AGN23001

**RE: Toms Creek (Pearce Farm)**  
**Case Number: CID-24-08**  
**Response to 2<sup>nd</sup> CD Review Comments**  
**AGN23001**

#### SL2.0 – PROPOSED LIGHTING PLAN

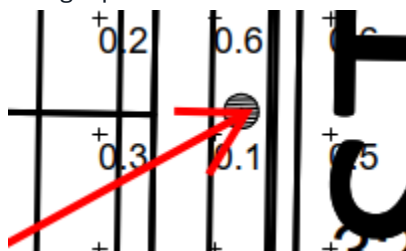
2. Lighting plans require professional seal. Please add to plans.

**McAdams Response: The Lighting plans have been sealed and signed by a Professional Engineer.**
